### Addendum

SR 161  
JOVITA BLVD. TO SR 18  
WIDEN - STAGE 1  
STPF-1009(002) & STATE

**Addendum No. 3**

**Addendum No. 1**

**TYPICAL SECTION - RETAINING WALL 1**  
REINFORCED CONCRETE RETAINING WALL TYPE 1  
STANDARD PLAN D-1a

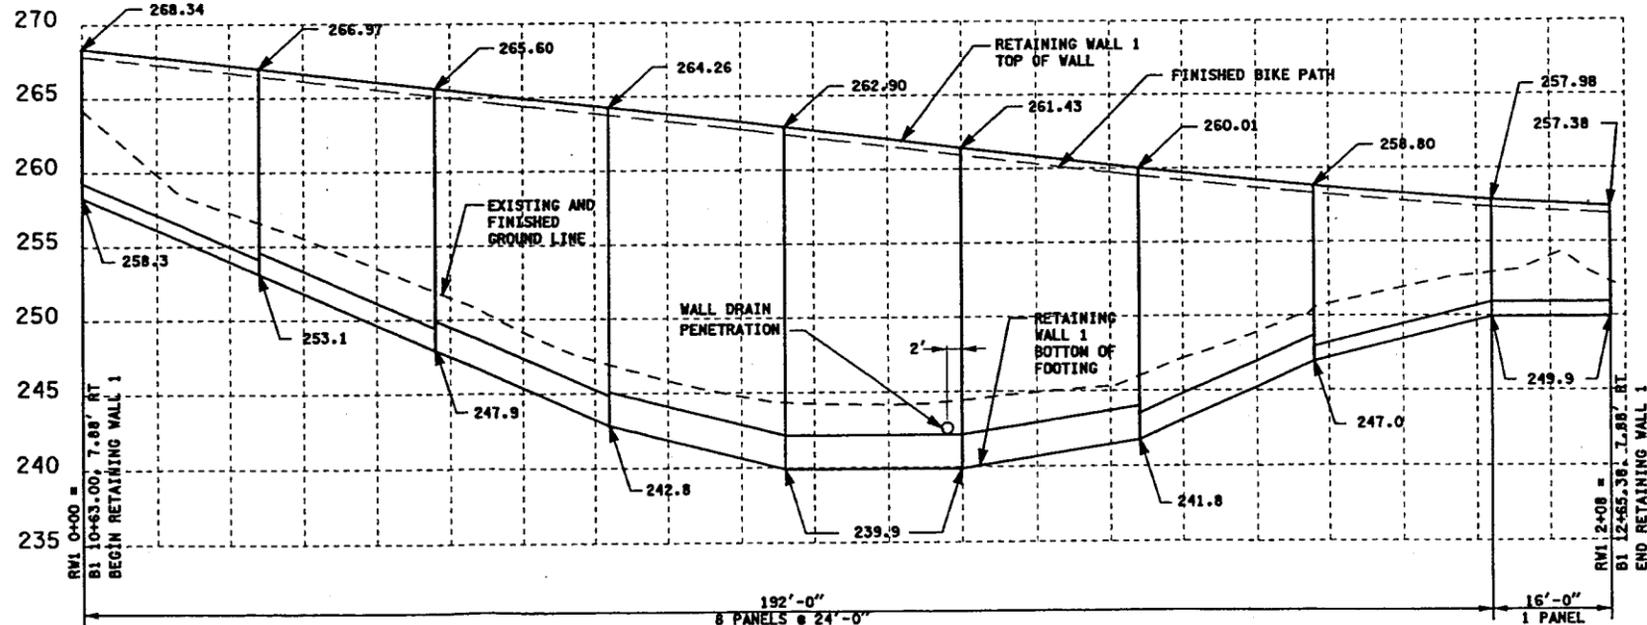
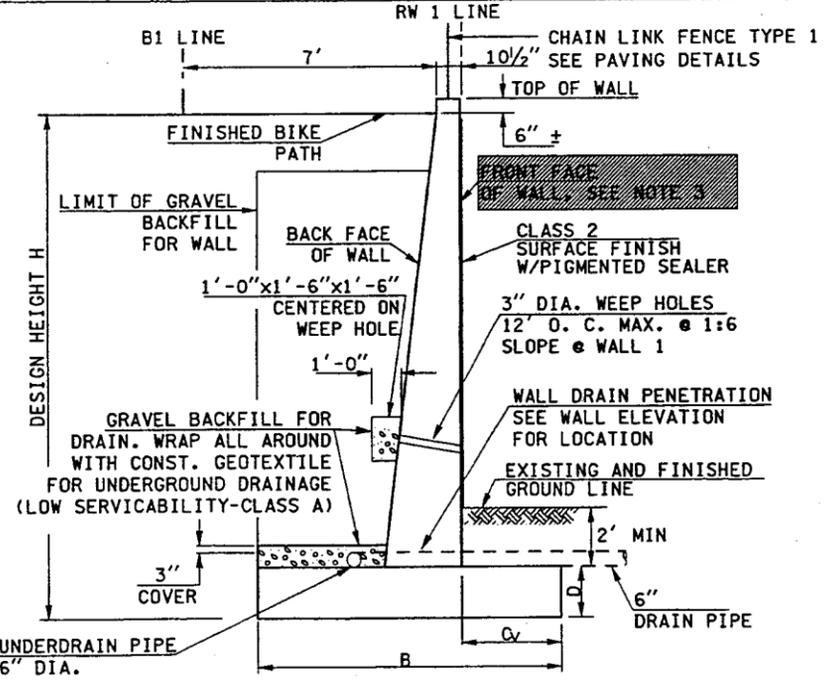
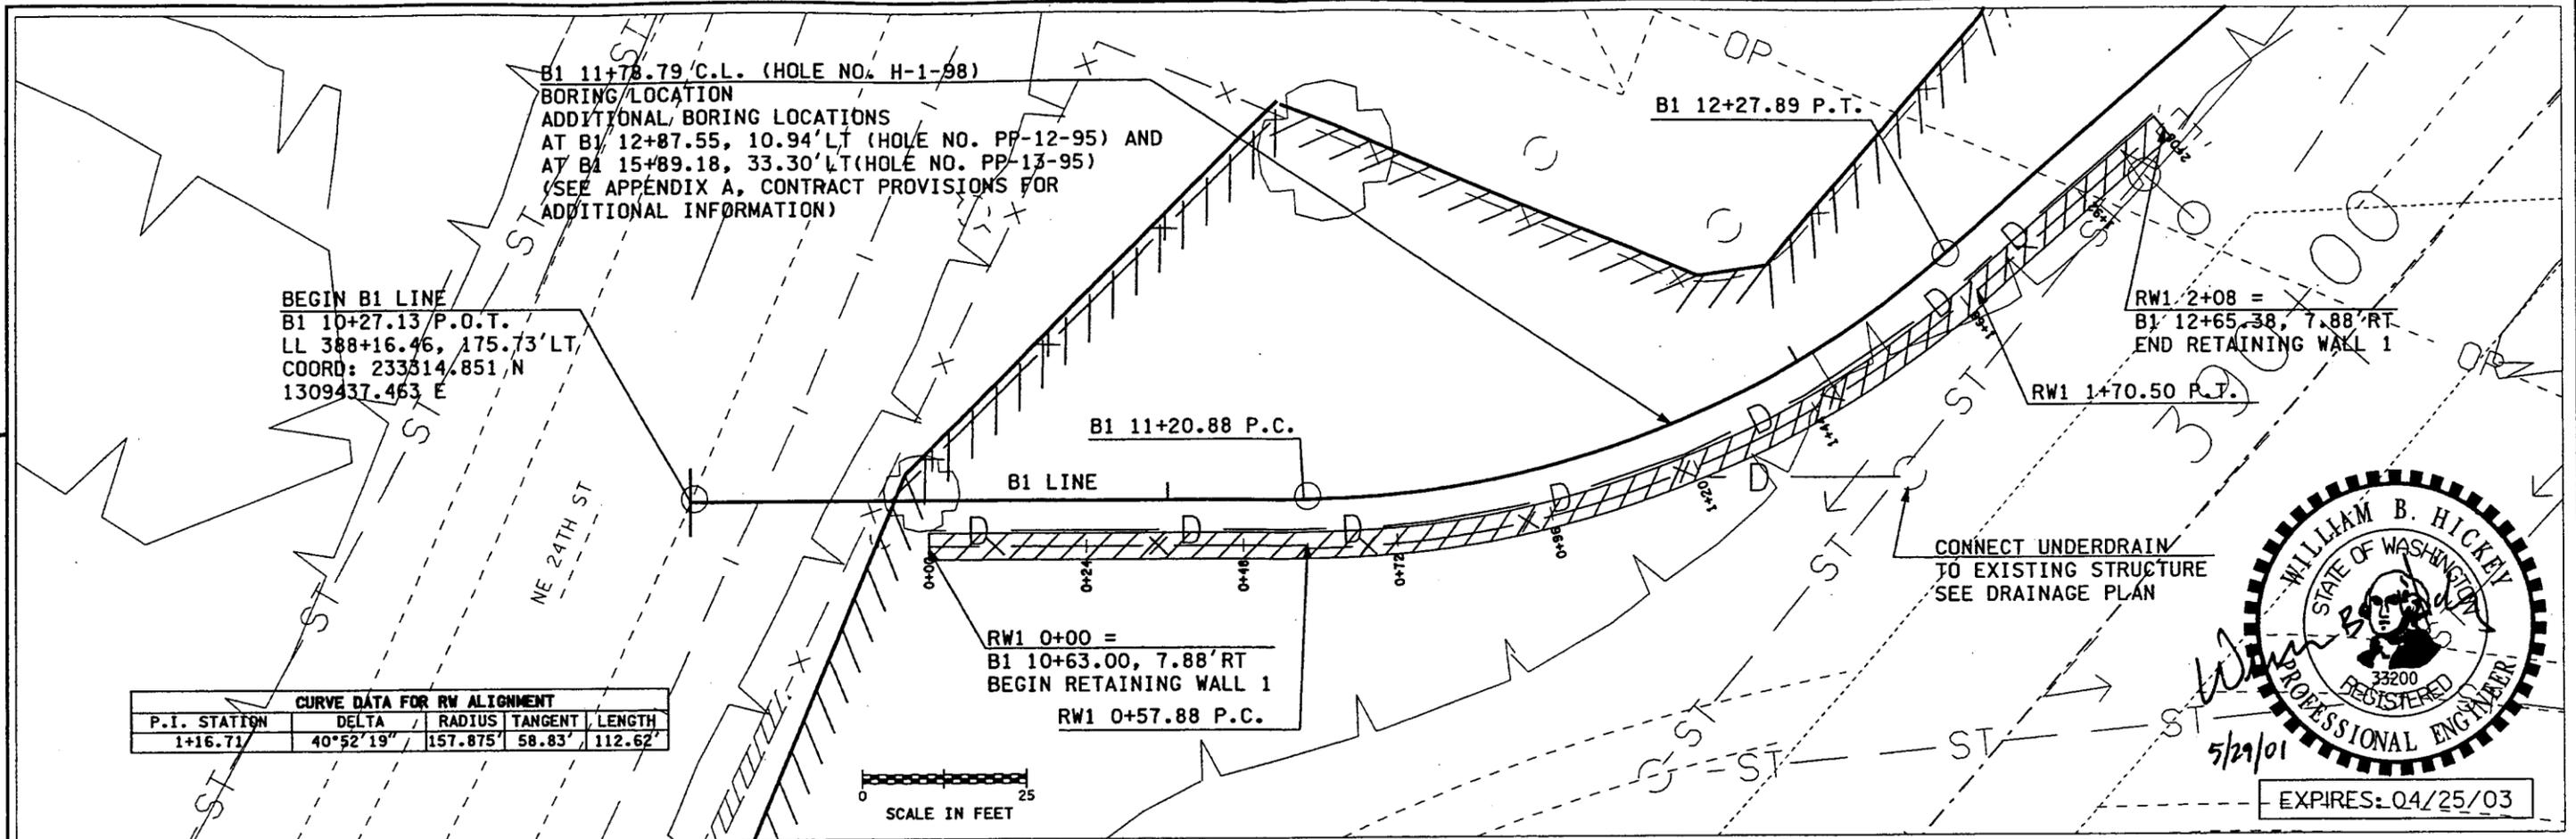
- NOTES:
- TOP OF RETAINING WALL 1 PROFILE IS CONTROLLED BY B1 LINE. SEE PR1 FOR B1 PROFILE INFORMATION.
  - THE PANEL LENGTHS OF RETAINING WALL 1 ARE MEASURED AT THE FRONT FACE OF WALL.
  - SURFACE TREATMENT SHALL BE RANDOM BOARD FINISH AS SPECIFIED IN THE SPECIAL PROVISIONS AND AS SHOWN ON SHEET M01.

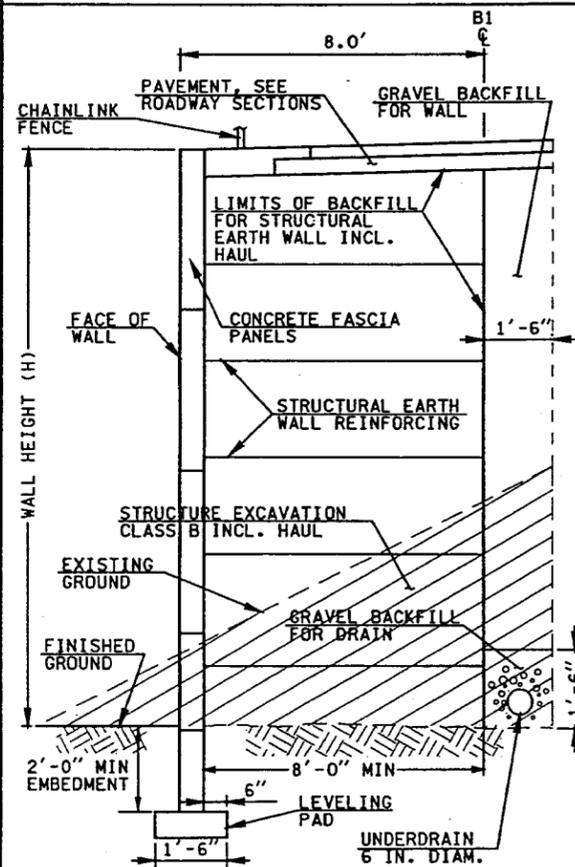
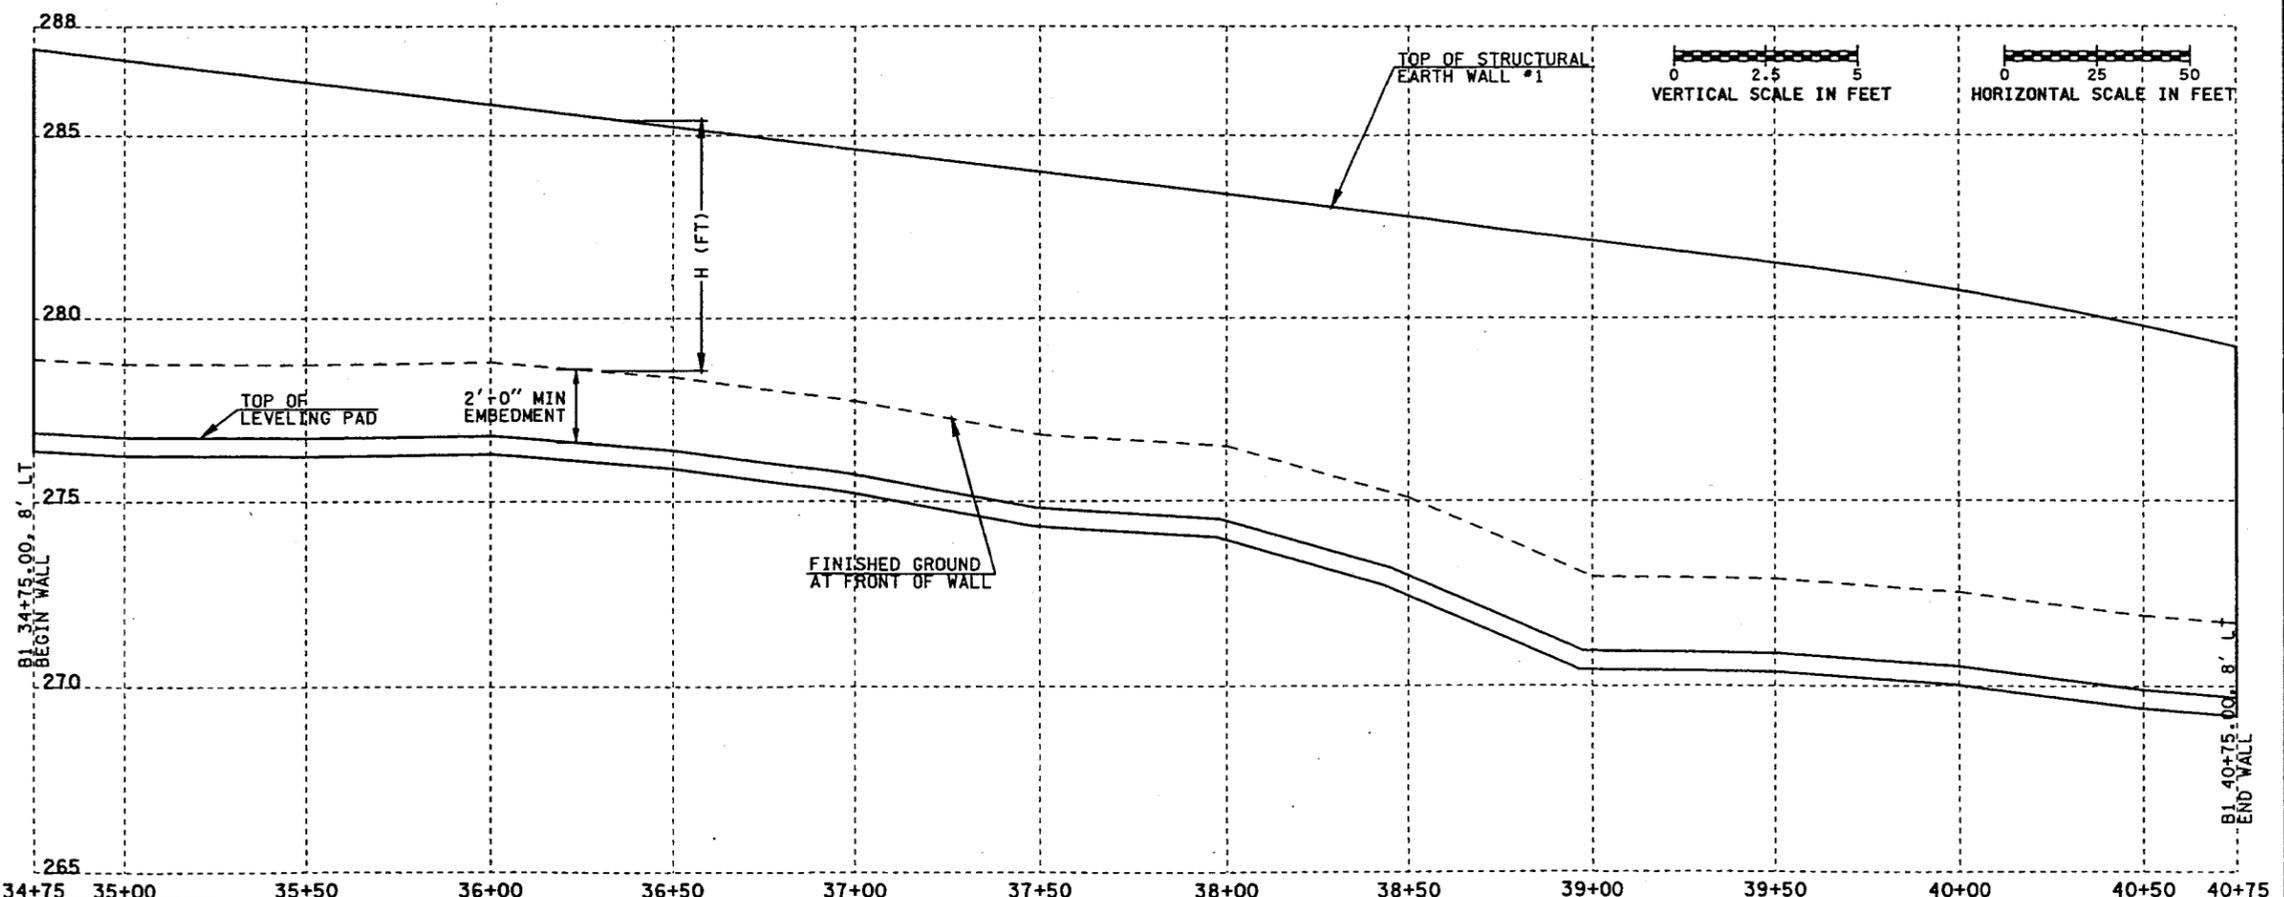
STRUCTURAL EARTH WALL #1  
NOTE: CONCRETE FASCIA PANELS SHALL BE RANDOM BOARD FINISH AS SPECIFIED IN THE SPECIAL PROVISIONS AND AS SHOWN ON SHEET NO.1.

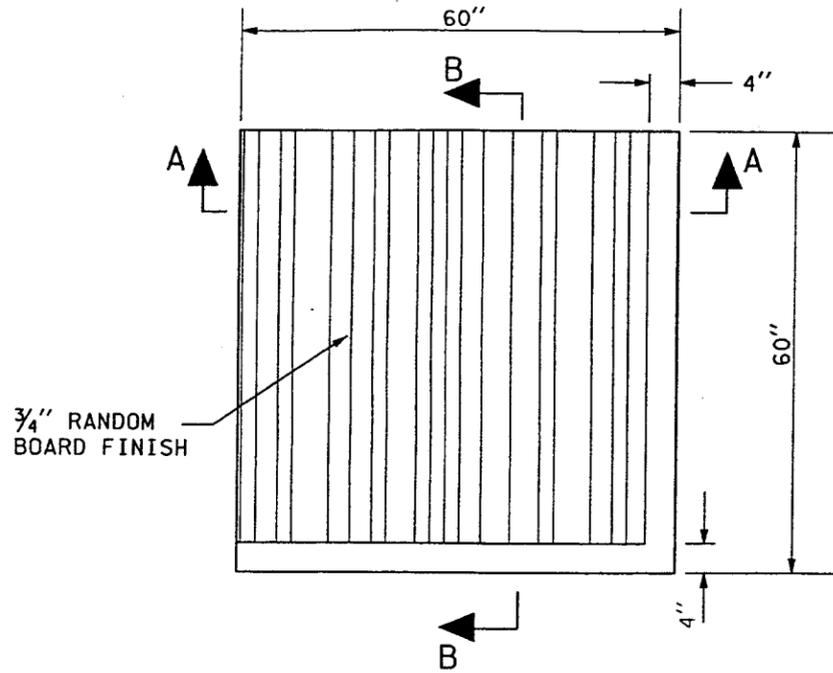
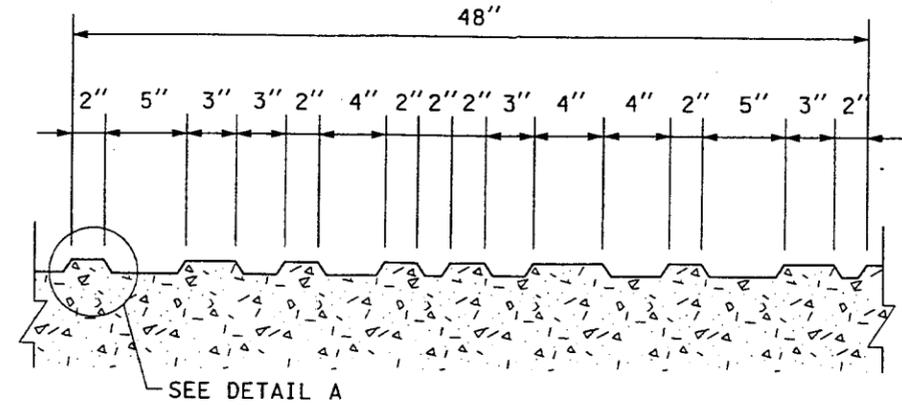
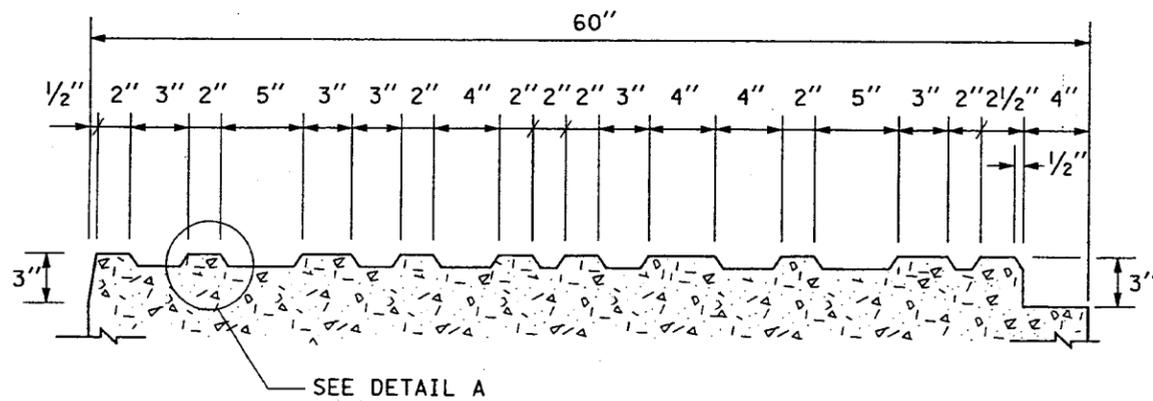
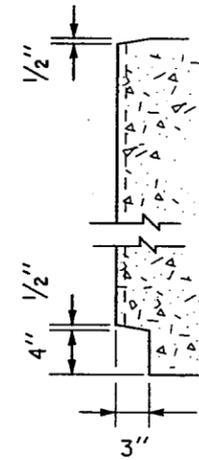
1. Page 140, line 52, to page 141, line 4 is deleted and replaced with the following:

3. On page 142, lines 2 through 8 are deleted and replaced with the following:

The 3/4 inch random board finish for concrete surfaces specified in the Plans to receive such a finish shall be achieved with reusable wooden forms conforming to Section 6-02.3(17)J and the texture pattern shown in the Plans. ABS, plastic, or elastomeric form liners shall not be used.

The texture pattern shall be accomplished with 3/4 inch thick battens in varying widths applied to the surface of the forms. The edge of all battens shall be sloped 15 degrees to facilitate form removal.
